SITE CERTIFICATION APPLICATION SUFFICIENCY RESPONSES

JEA Brandy Branch Combined Cycle Conversion

JEA-Brandy Branch Sufficiency Response - 99262

Re: JEA-Brandy Branch Conversion Project
Site Certification Application
FDEP File No. PA 00-43
DOAH Case No. 00-5120EPP
OGC Case No. 00-2321
Response to Statement of Sufficiency
PSD-FL-310
0310485-004-AC

Preconstruction Land Use and Cover Brandy Branch Generating Station

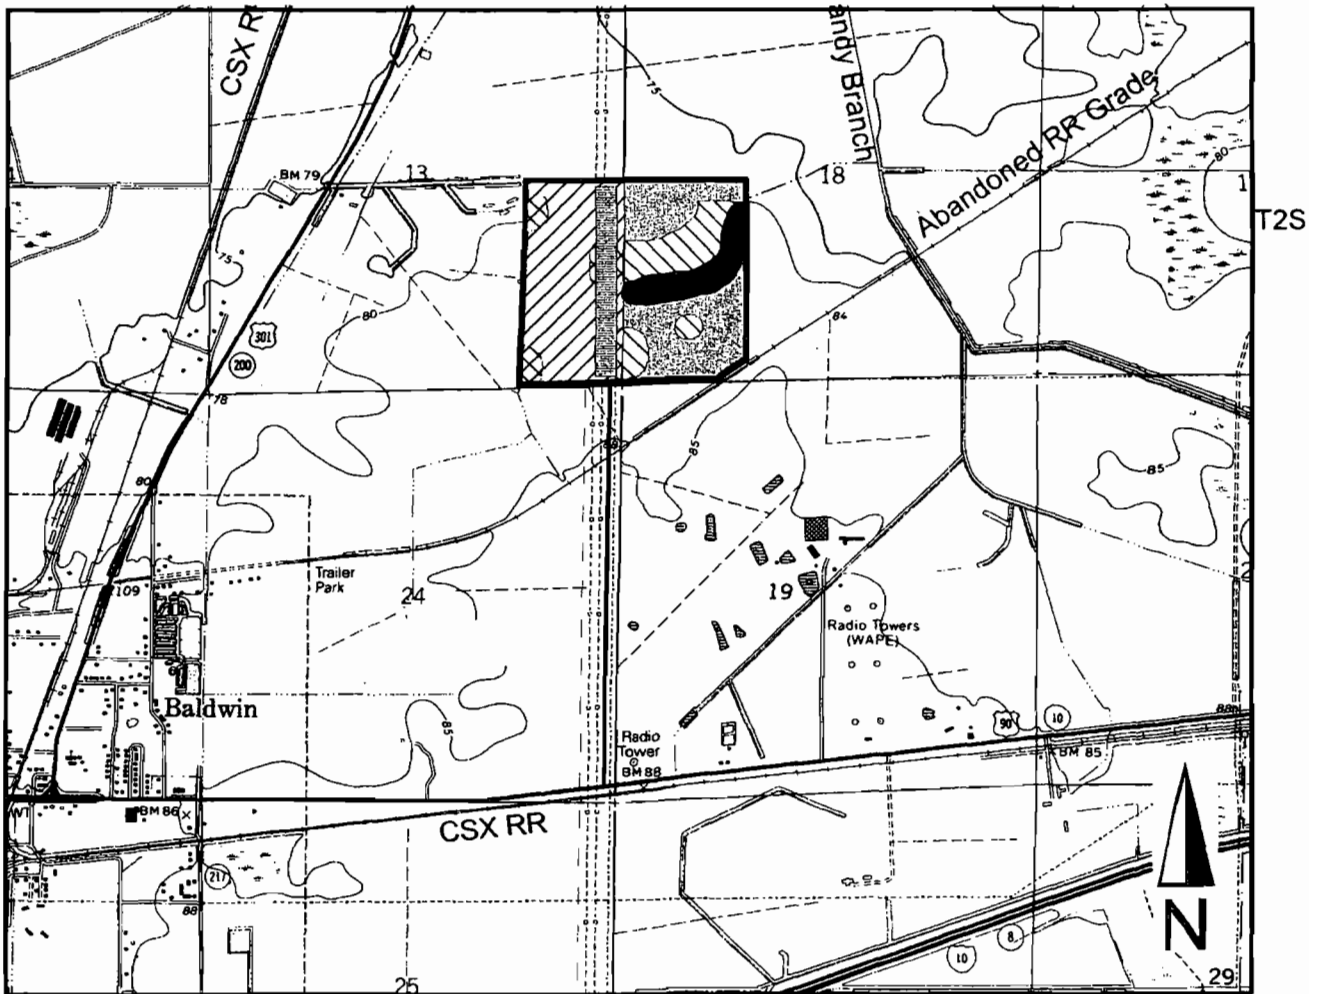
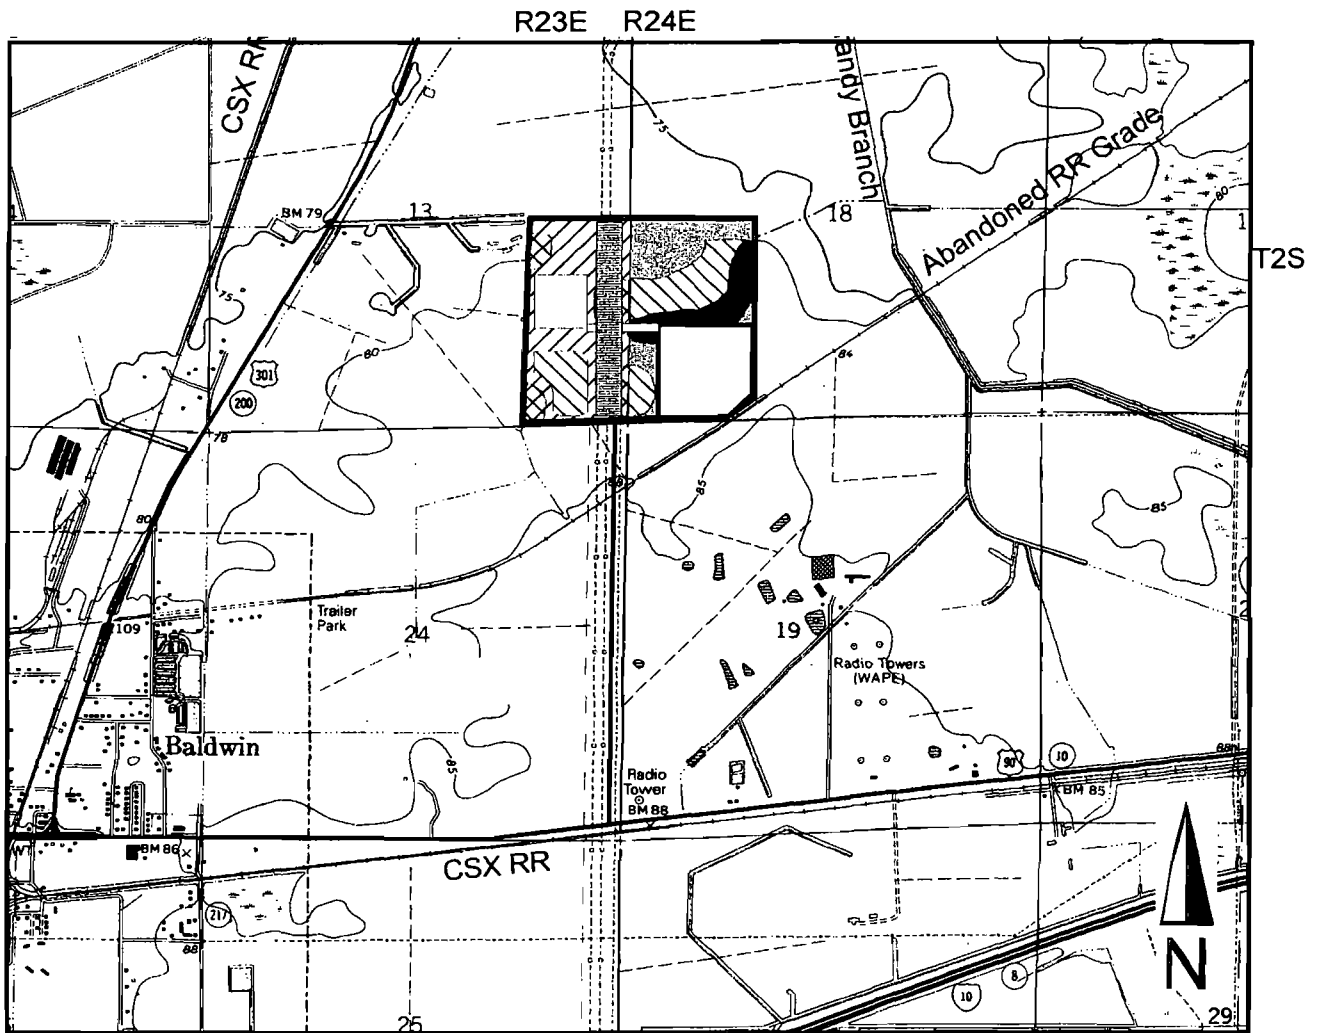
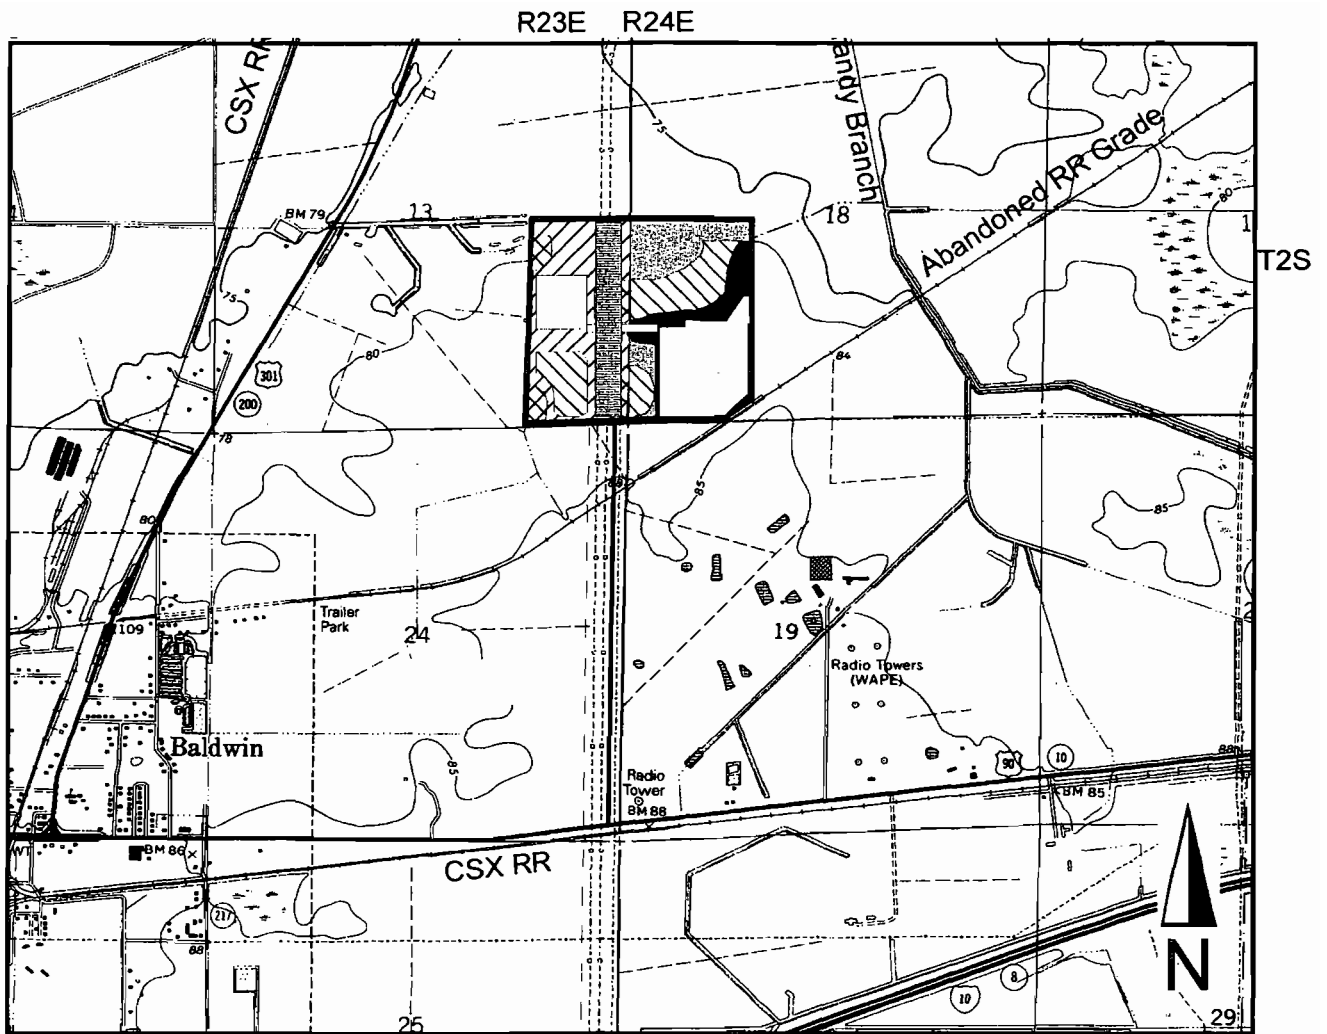
1. *In reviewing the site application, it was difficult to determine what the current conditions of the site are, or how much of the site has already been altered for construction of the first three units. The descriptions of vegetative communities of the site apparently were prepared prior to the current construction activities, and do not describe what will be impacted by this conversion project. The application mentions an additional 2.5 acre area of pine woods to be cleared, but does not provide any detail about this area. The applicant should provide a vegetation map showing current vegetative cover, with the footprints of new facilities needed for the conversion project clearly indicated.*

Response: Pre-construction land use / vegetative cover for the Brandy Branch Generating Station site is illustrated in Figure 1. Actual land use / vegetative cover for simple cycle construction of the Brandy Branch Generating Station site is illustrated in Figure 2. Figure 3 represents the proposed land use / vegetative cover for combined cycle construction of the Brandy Branch Generating Station site.

Construction of the simple cycle facility began in November 1999. To date, all areas (42 acres) scheduled for construction have been fully developed. Please note the additional combined cycle construction area in the northeast corner of the power block area for the cooling tower and associated piping. A more detailed view of this locality showing the plant footprint and additional construction area is illustrated in Figure 4. An additional total of 2.96 acres of conversion / cooling tower impact are expected at the location, with 2.5 acres composed of pine flat woods and 0.46 acres composed of coniferous plantation.

Hydro-stratigraphic Cross Section at JEA Brandy Branch Site

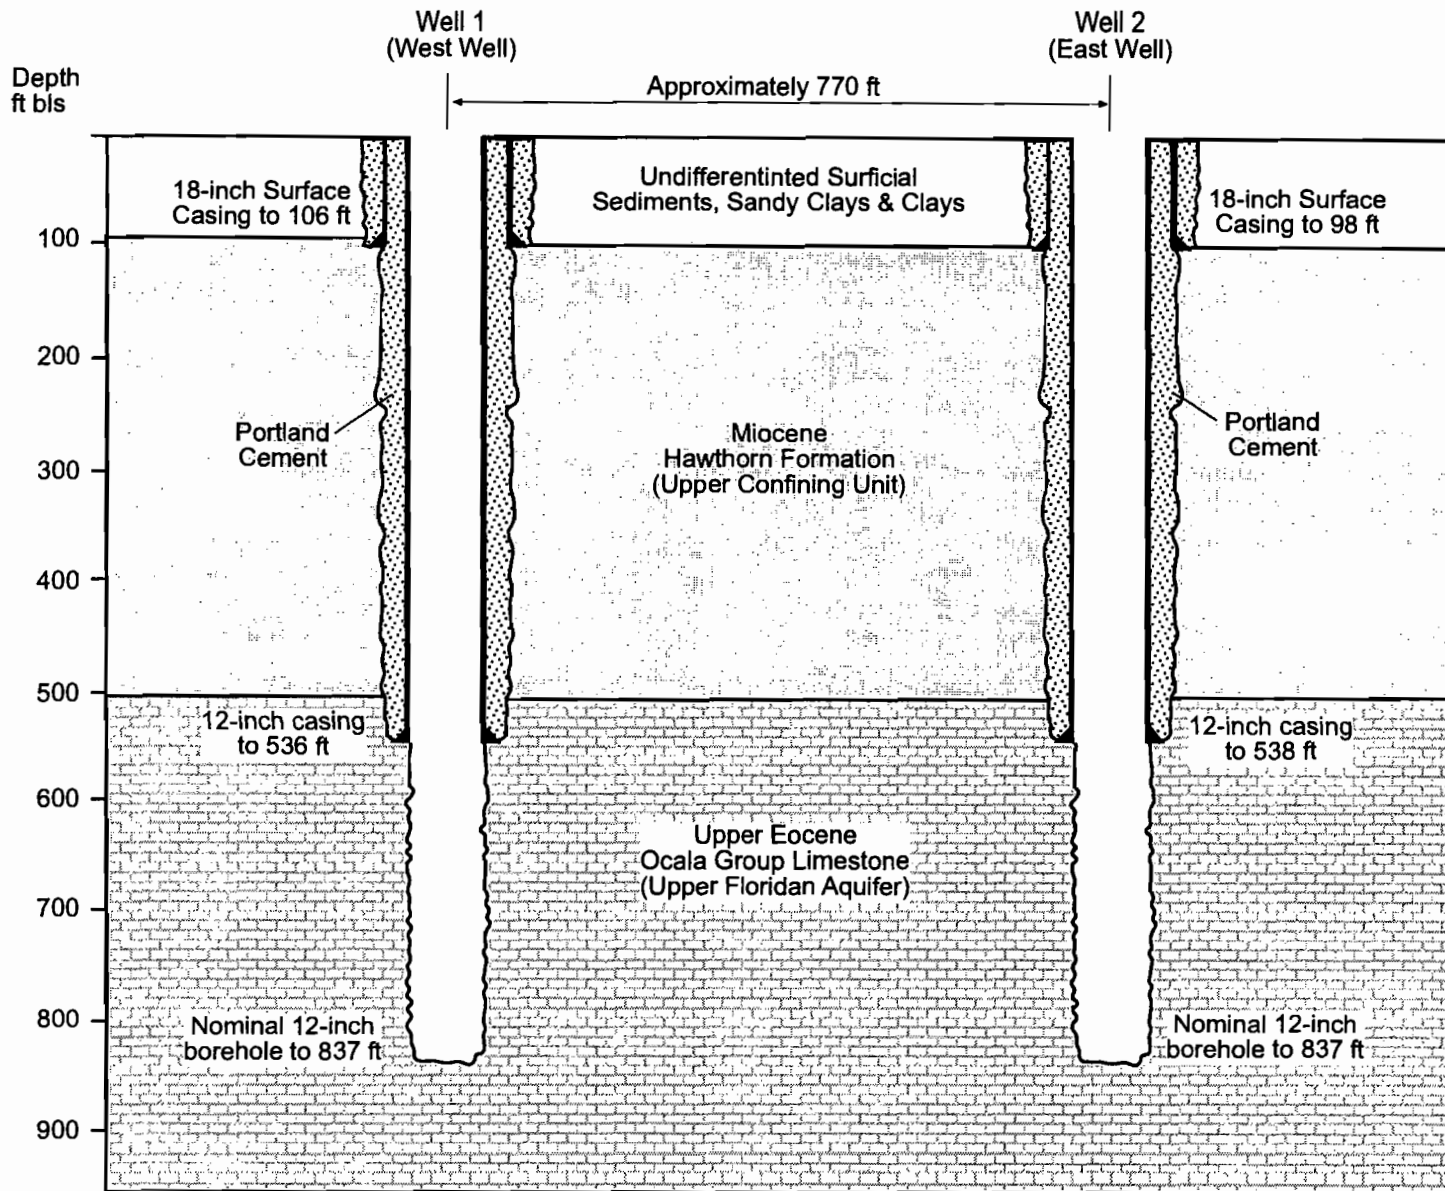
1. *The application indicates that there are herbaceous and forested wetlands as well as other surface waters on and surrounding the proposed site. The ground water modeling, however, analyzes the drawdown impacts to the Floridan aquifer only. Please provide an analysis of the steady-state impact of the proposed Floridan aquifer withdrawals on the surficial water table at the maximum proposed pump rate of 2.744 million gallons per day (mgd) and at increased rate of 3.722 mgd for 288 hours, transient conditions. The drawdown contours should be overlain on a map of wetlands and surface waters and displayed at one-half foot intervals and also delineate outward from the well(s) to the 0.2 foot drawdown contour. [Section 10.2(e)(f)(g)(l)(p), 10.3(d), Applicant's Handbook Consumptive Uses of Water (February 8, 1999) (A.H.)]*

Response: Exhibit 1 shows a hydro-stratigraphic cross section at the site with the completion details of the new production wells. The data collected during the pumping tests of the "east" well in May and June of 2000 was reviewed. During the test, a transducer was set in the shallow aquifer "rock" zone temporary water supply well at the site. The shallow rock zone well was located several hundred feet west of the pumping well and was completed into the carbonate rock at the base of the shallow aquifer approximately 100 feet in depth. Exhibit 2 shows the depth to water in this well during the constant rate test of the "east" Floridan aquifer water supply well. No obvious correlation in water level change is apparent. Although there is a general downward trend of about 0.05 feet during the 48-hour test, the trend continues through the recovery phase of the pumping test. If the water level drop were related to pumping the underlying Floridan aquifer, the water levels in the shallow rock well would have recovered when the pump was shut off. The trends noted on Exhibit 2 were likely caused by variations in barometric pressure and changes in local domestic demand. This shallow rock aquifer is used in this area for domestic supply purposes.

Figure 1: Wastewater Sump Dewatering

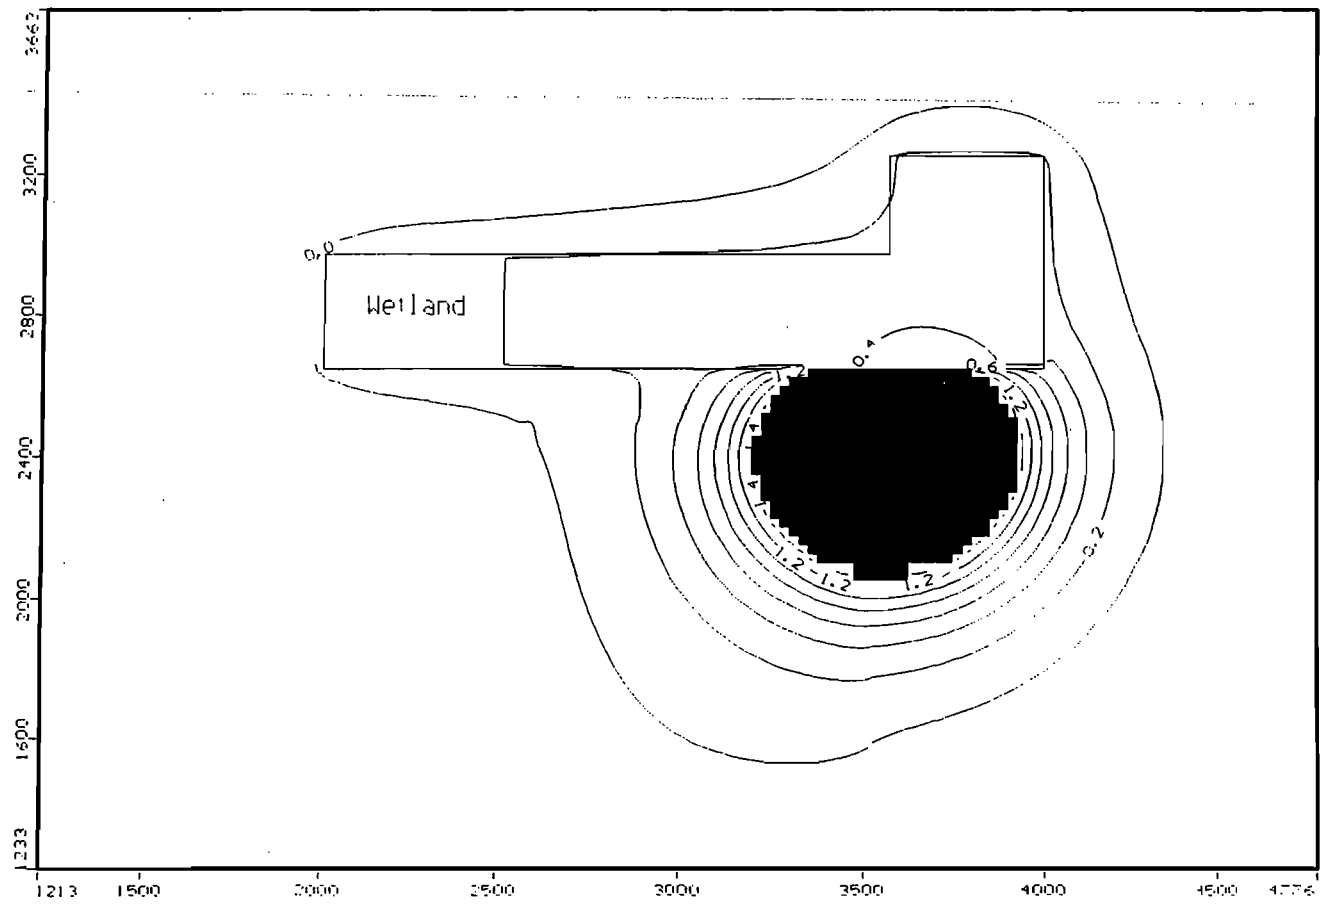
2. *Please provide reasonable assurance that impacts to wetlands and surface waters from the proposed drawdown will be reduced to an acceptable level. This would entail a field evaluation of the wetlands that may potentially be impacted. Please contact Robert Epting at (904) 329-4163 for a further discussion of the evaluation process. [Sections 9.4.1(b), 9.4.3(a), 10.2(e)(f)(l)(p), 10.3(d); A.H.]*

- The only wetland that will be impacted by dewatering is immediately north of the plant site.
- Dewatering for the wastewater sump excavation will have no impact on the wetlands (see attached Figure 1).
